DEPARTMENT OF HOUSING AND URBAN DEVELOPMENT

24 CFR Parts 3280 and 3285

Model Manufactured Home Installation Standards

ACTION: Final rule.

Figure to § 3285.203 - Grading and drainage.

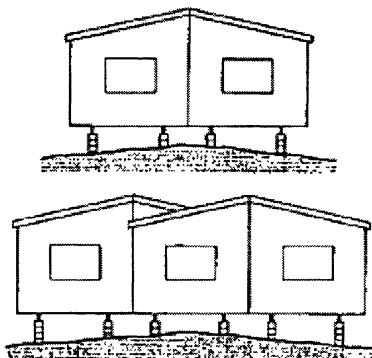
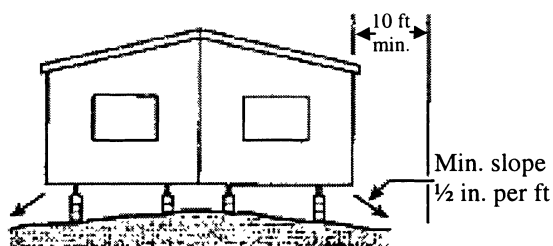
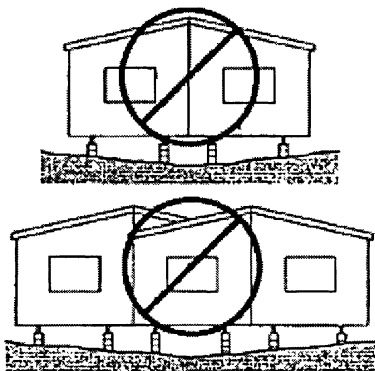
Comment: § 3285.203(a) Drainage. The section should be revised to read as follows: "Drainage must be provided to direct surface water away from the home." This was suggested because the commenter believed it unnecessary to include a "laundry list" of possible problems, if proper drainage was not provided, that was identified in the proposed rule.

Comment: As written, subsection (b) would be impossible to enforce within rental communities given their layout and design. The requirement should be revised to provide an exemption for homes sited within manufactured home rental communities, or by changing the drainage requirement "from under" to "away from" the home. Further, in subsection (c) the first 10-foot provision would be impossible to enforce in rental communities, since lots only provide for 5-foot sideyards and that the requirement should be revised to require drainage away from the foundation of the home for the first 5 feet.

HUD Response: The final rule has been revised to clarify that surface water must be directed away from the home to prevent water build-up under the home. Where property lines do not allow the drainage to be diverted for the first 10 feet from the foundation, other methods are allowed to remove the surface water. However, statements on the adverse affects of not removing the water have been removed from this section, as suggested by commenters.
